Item 9 - Correspondence

[Item 9- Flats at Knowles Station Preliminary Plan No. 12021003A & Site Plan Amendment](#)

[No. 82021003A](#)

DES. R.R.P.	MONTGOMERY COUNTY MARYLAND
CHK. D.L. BROWN	DEPARTMENT OF TRANSPORTATION
	ROCKVILLE, MD.
REVISIONS	STORM DRAIN PLAN
	SUMMIT AVE. AND KNOWLES AVE.
	PLAN VIEW
	APPROVED
CHEF, DIV. OF TRANS. ENG'G.	DIRECTOR, DEPT. OF TRANS.
PROJECT: 748818	DWG: 2 OF 5

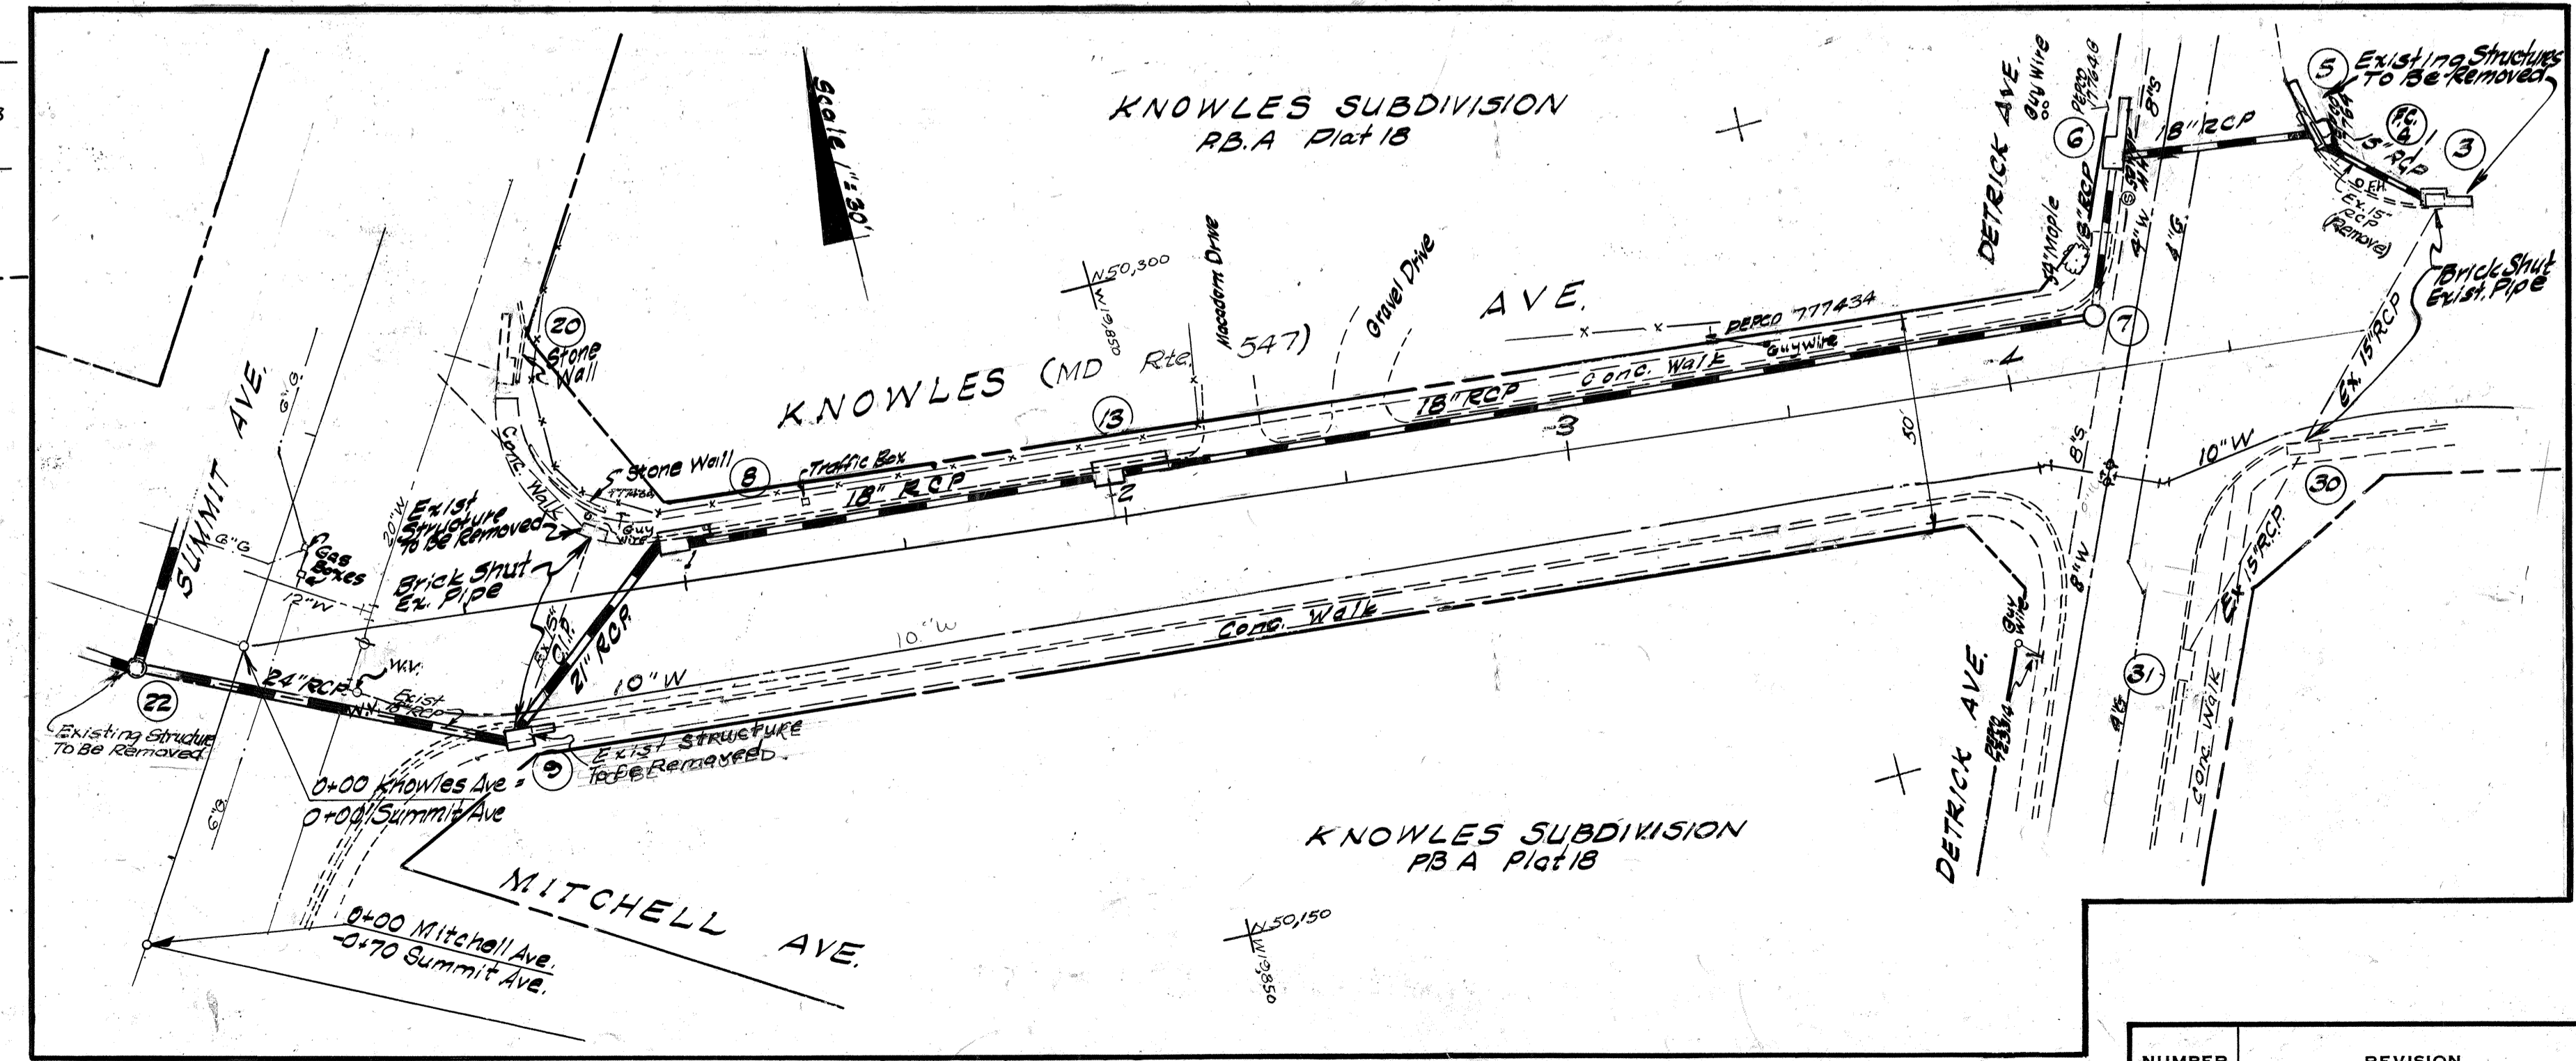
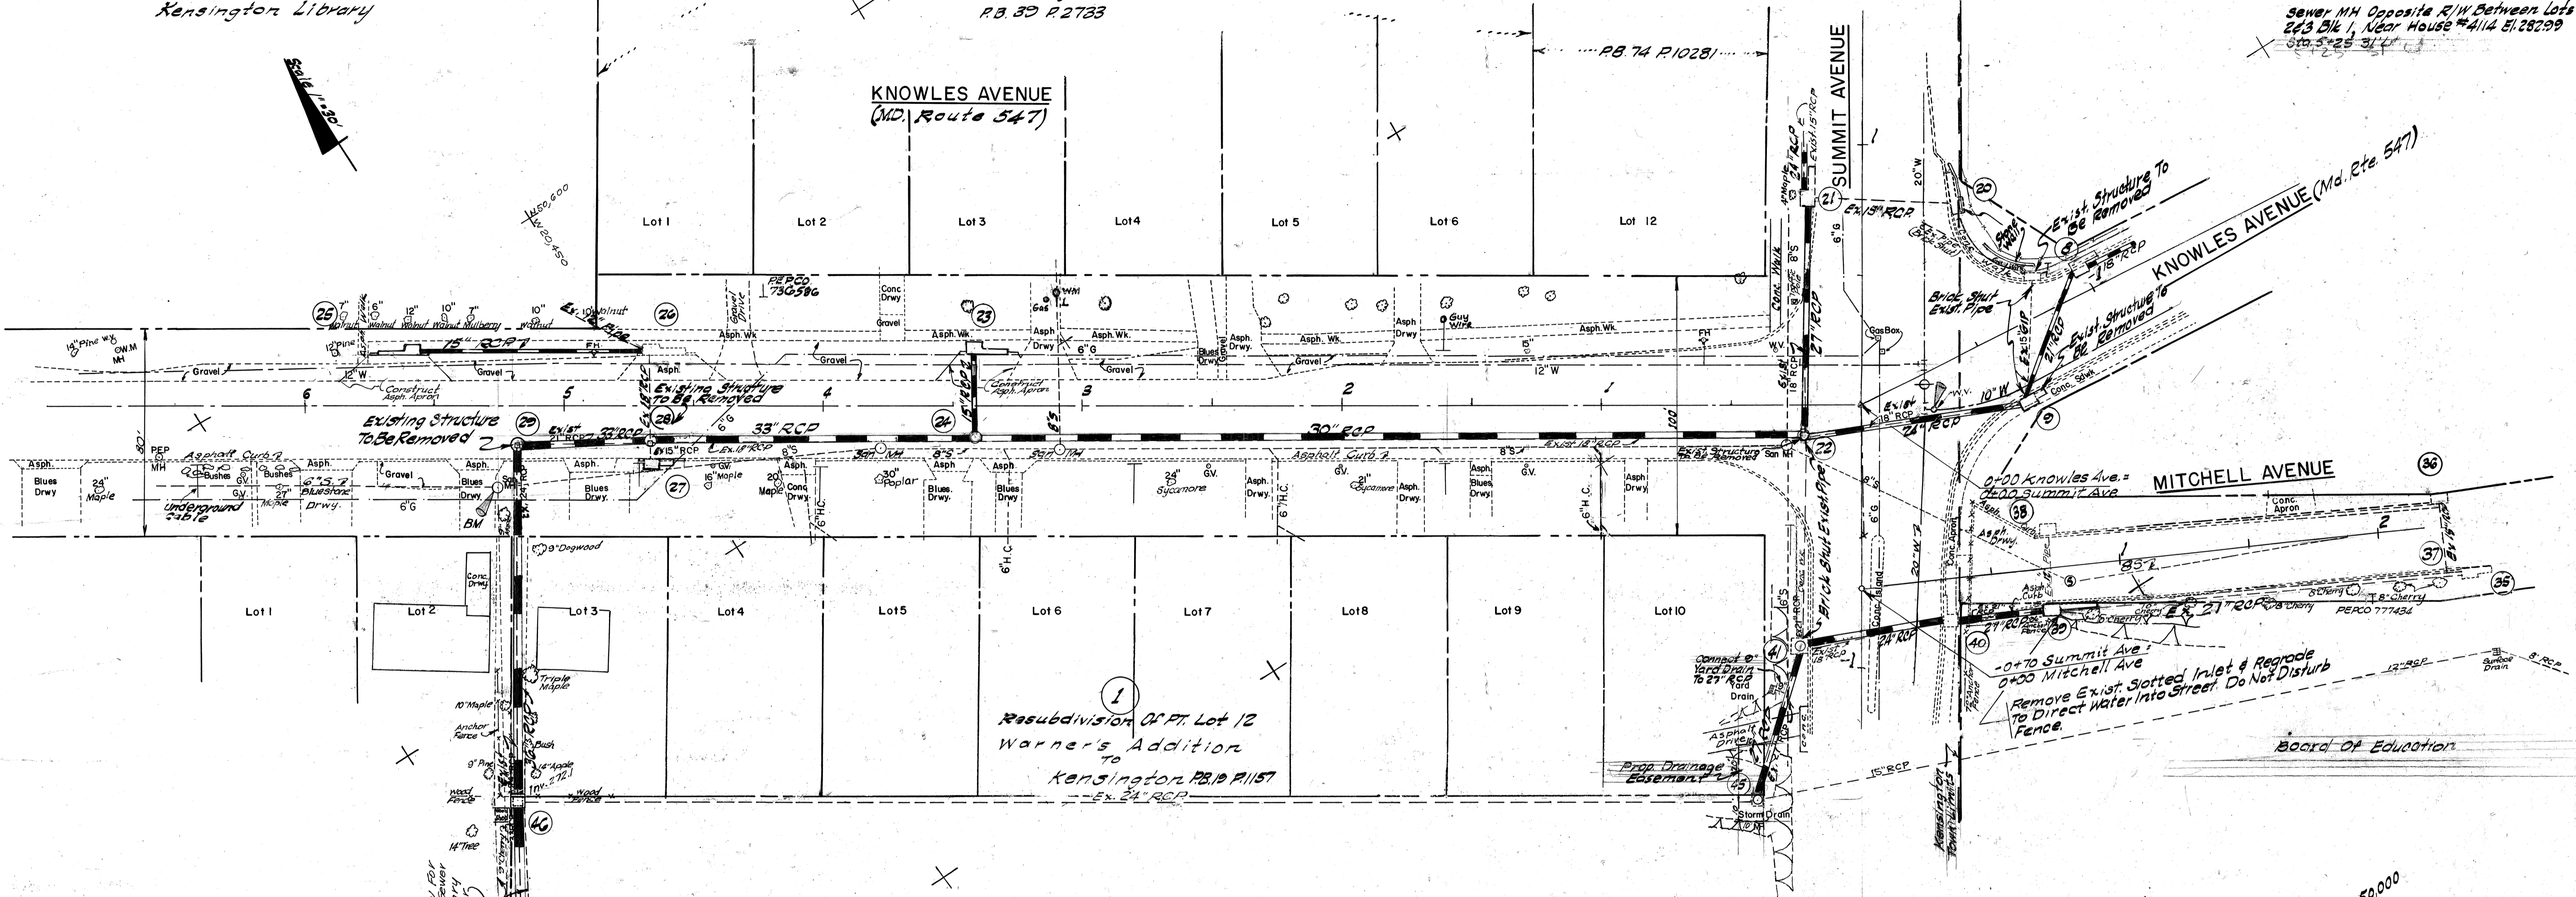
These plans show drastic changes that were to be made to our system. Pipe size increases from 18 to 30 in, 24 to 36 inches, 33 to 42 inches, 18 to 24 inches. Adding of new lines completely, and bricking some closed to alleviate flow to an overburdened line.

One such line, that was to be isolated, is the 24' line that runs in the ground between the houses on Knowles and Warner. This line was reported to the neighborhood several times as nothing from the

1. The plans that were drawn up a minimum of 40+ years ago, to alleviate the flooding we are encoring, but were never acted upon.
2. The publicly funded Engineering report provided by the HOC, Spelling out the following:

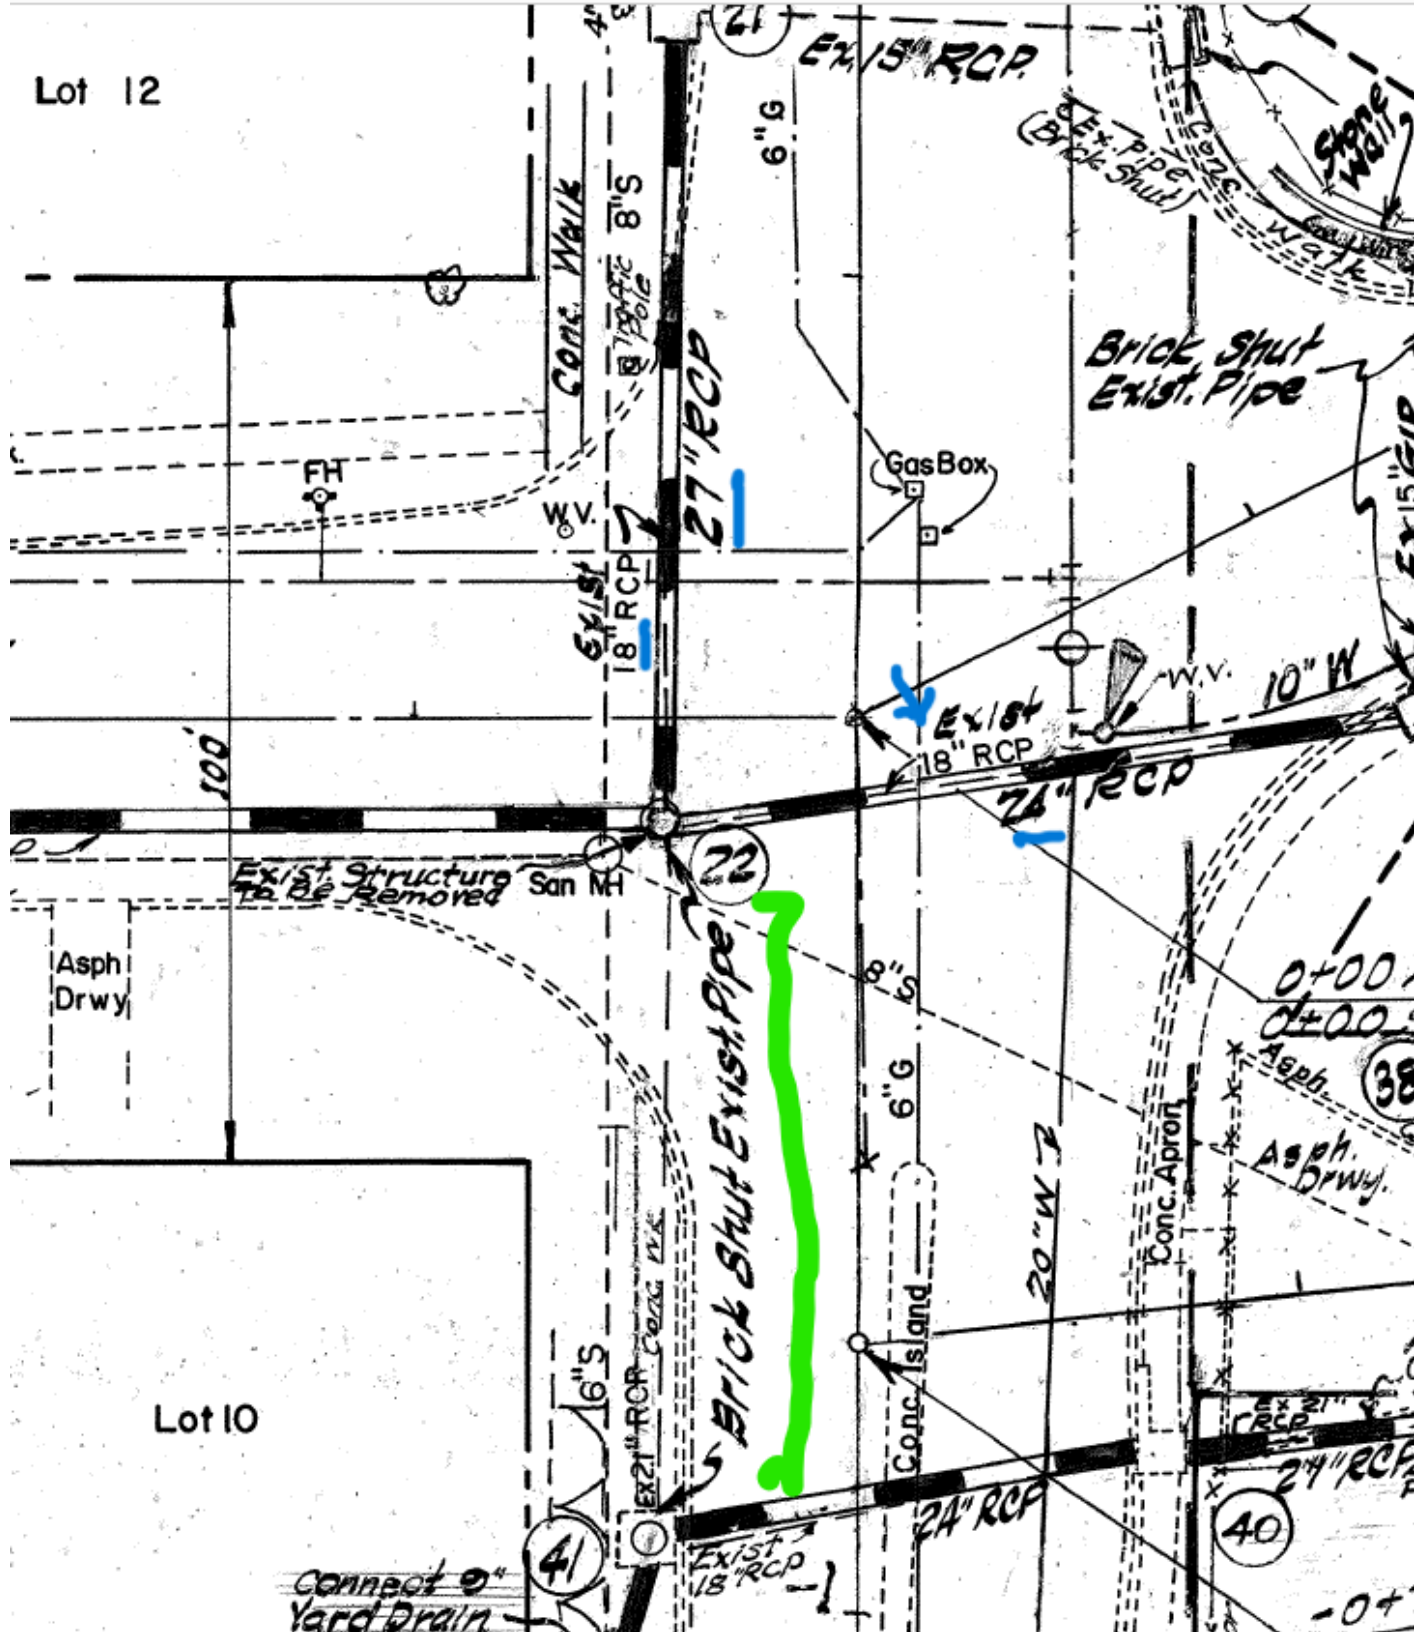
4. A snip of the Plans that showing there was supposed to be a barrier placed in the storm drain line to not allow stormwater to flow towards the line that does not have a easement. The project being voted on today, will be flowing in this line, not blocked.

- a. Please note, the drain line sizes in this snip shows the sizes we should have, not what we do have. Ex. The line heading south from the top says 27", it is only 18". The line in the middle says 24", it is only 18", the line in the bottom says 24", it is only 18". (These are the plans that were drafted in the 70's, but never completed. The same ones the Engineering report refers too being given, but not accurate)

MASTER PIPES:

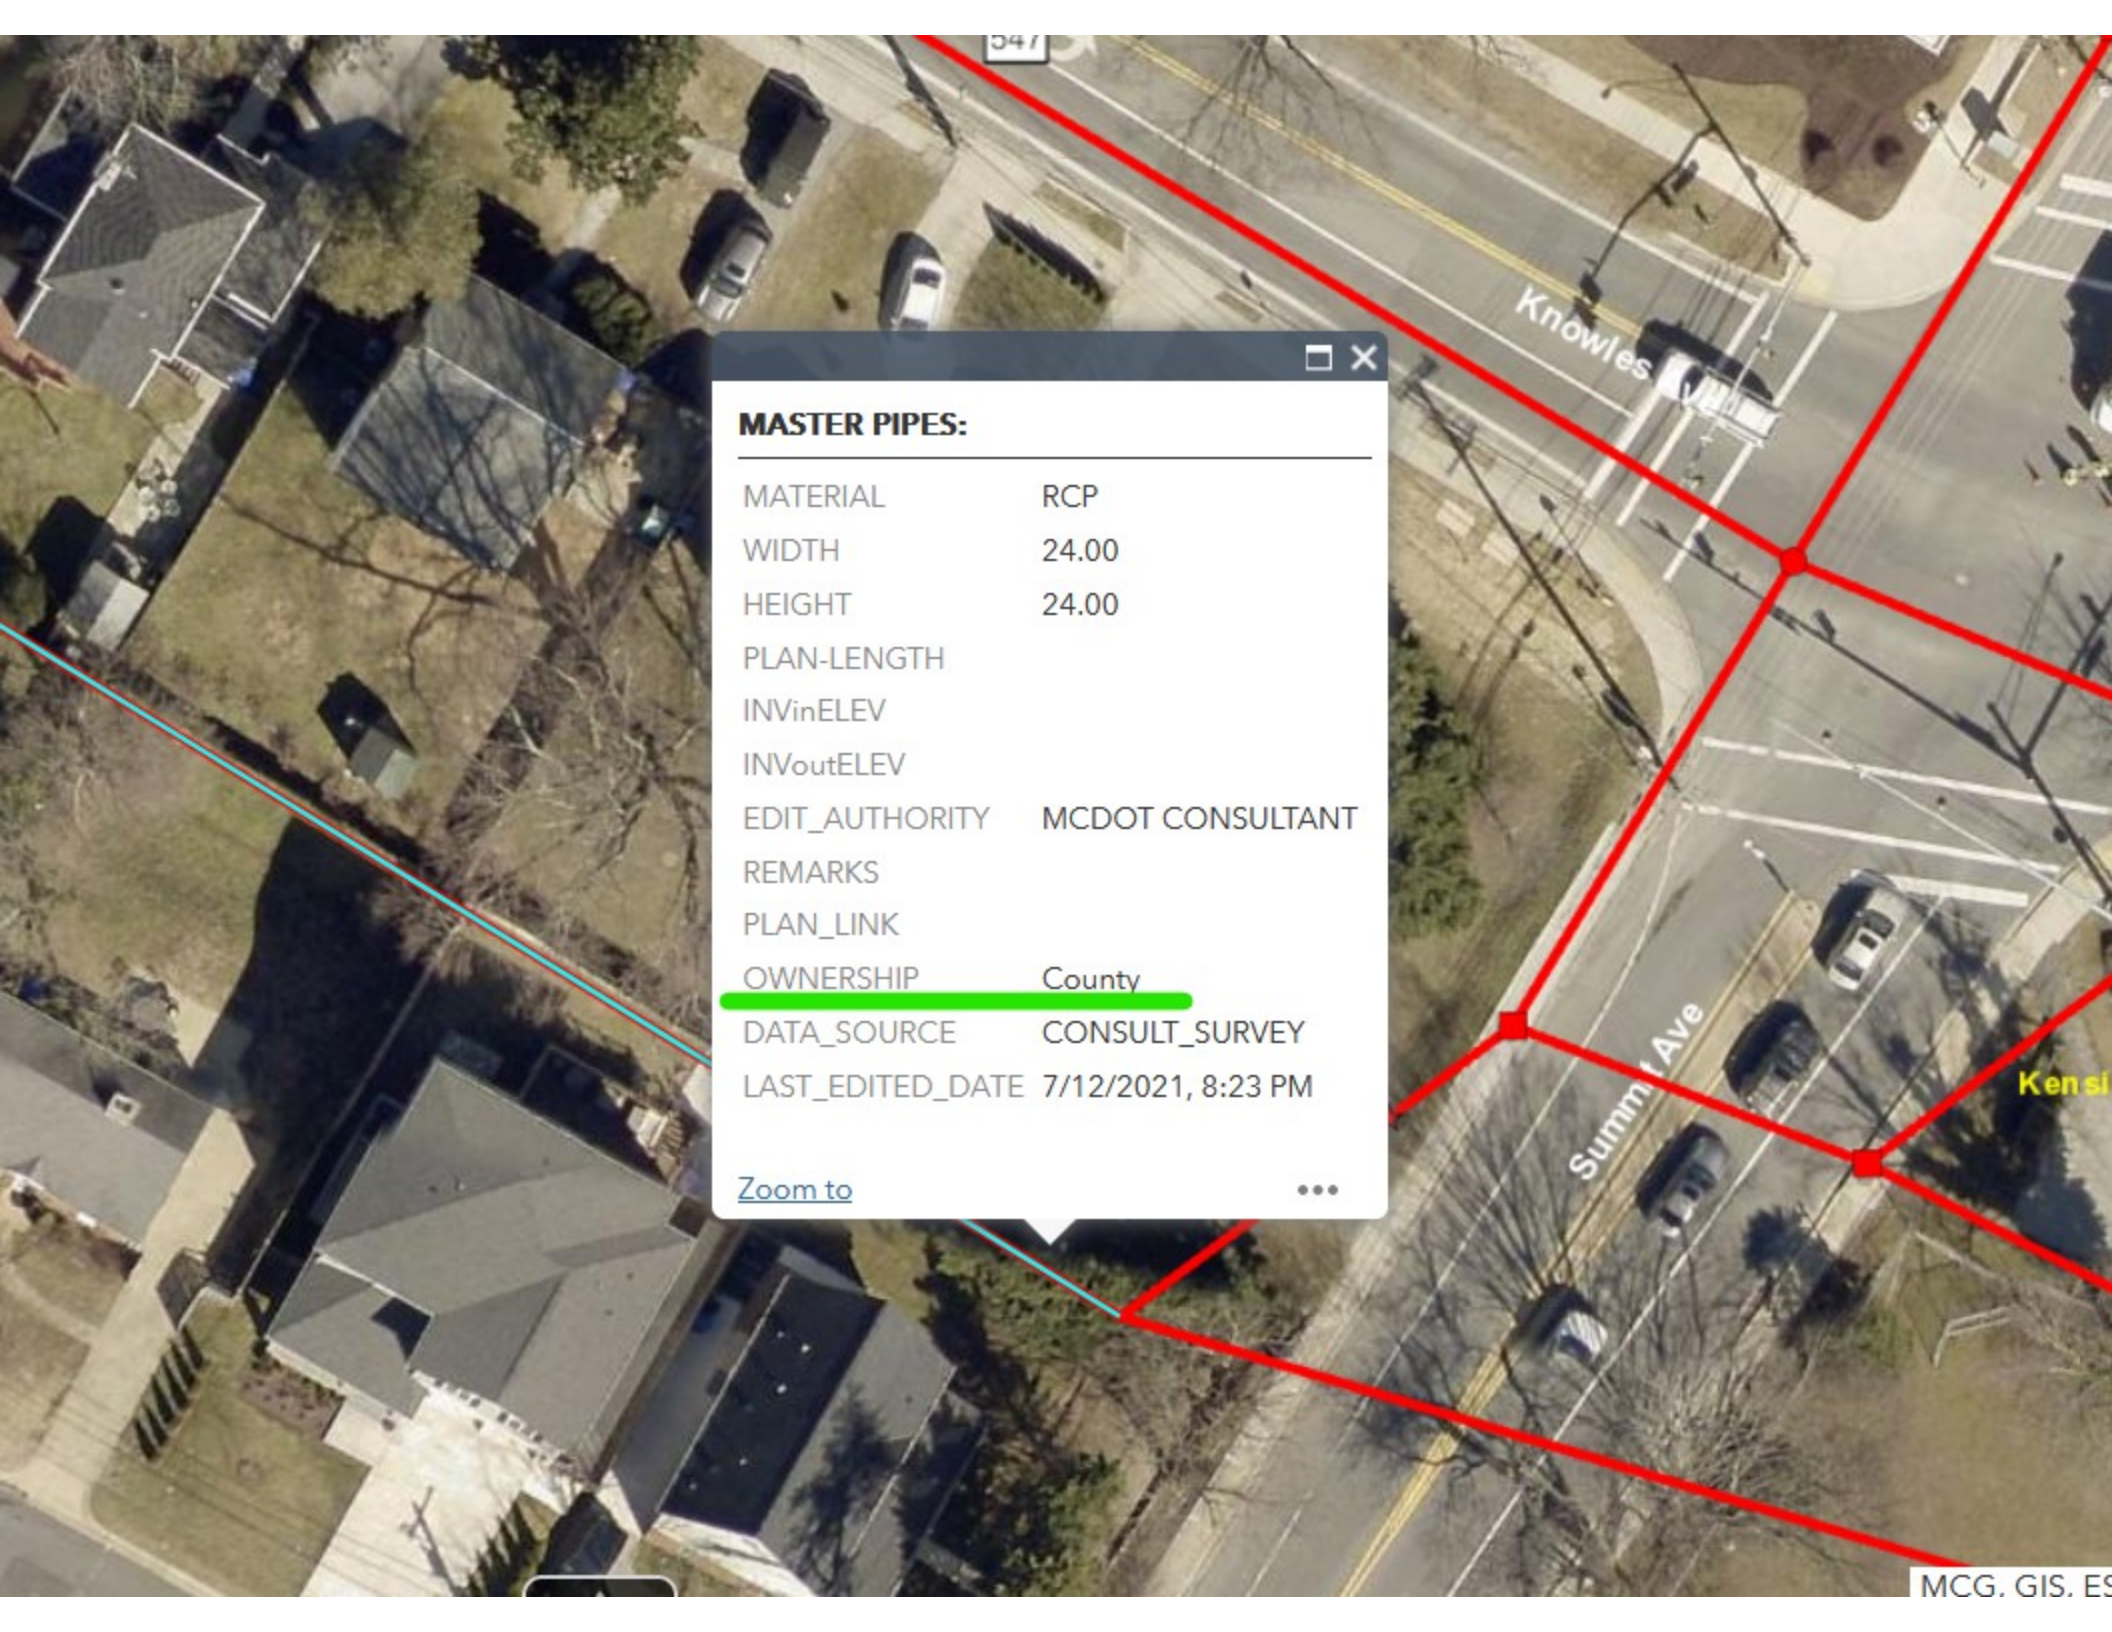
5. A snip from the Stormnet system that shows County ownership of the line that has no easement
